Correctional service Canada

ADDENDA No 3

Construction of building for the emergercy intervention team lot #3

Projet no : 550-2-368-3205 JANUARY, 10 th 2014

PA-3.3 : Sheet A03/05

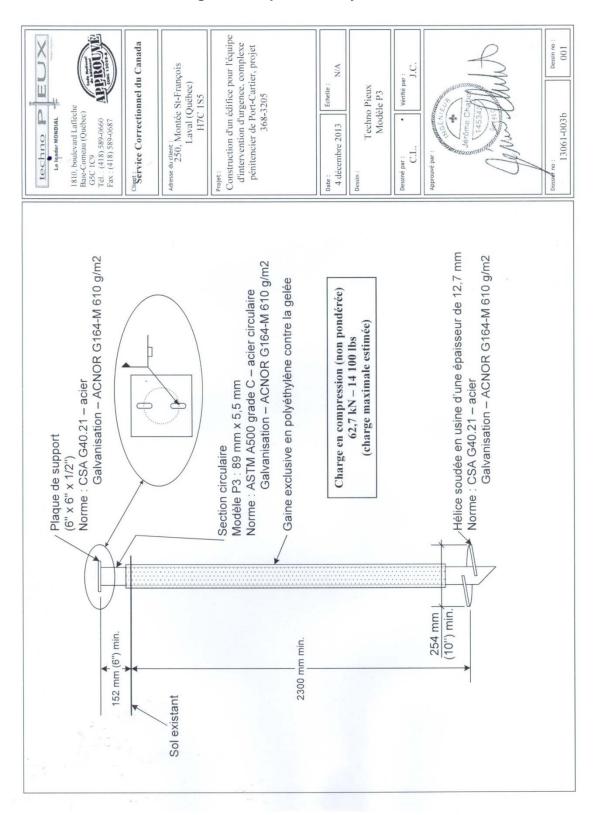
- 1. Disregard of R values described in the section of wall to the floor, walls and roof.
- 2. In footnote 2, provide an uninsulated below the trailer same materials as it skirt. Provide access door 610 mm x 915 mm.

Pictures of the site where the new building will be installed

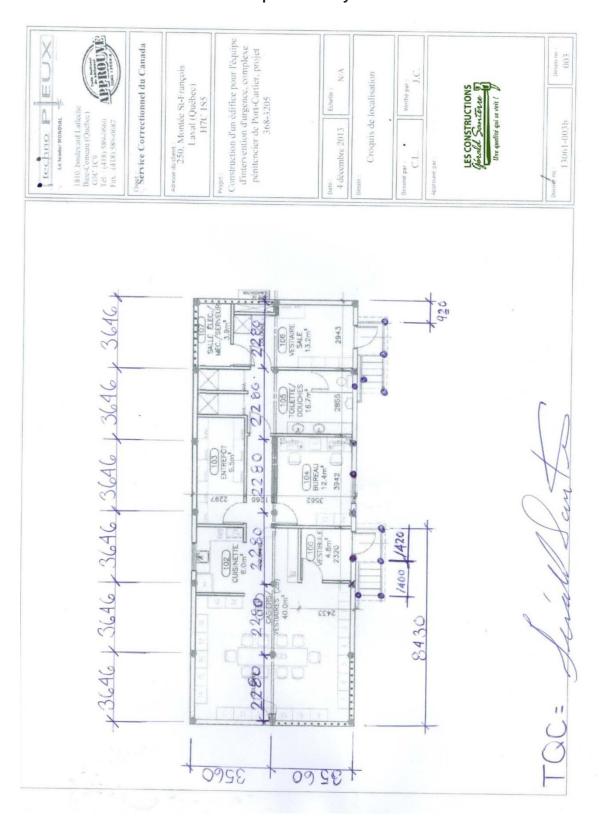
1. See sketch attachments for spacing and type of piles installed on-site for future building.

The site visit will not take place, the new building for the intervention team is provided outside of the enclosure, see photos attached to the document.
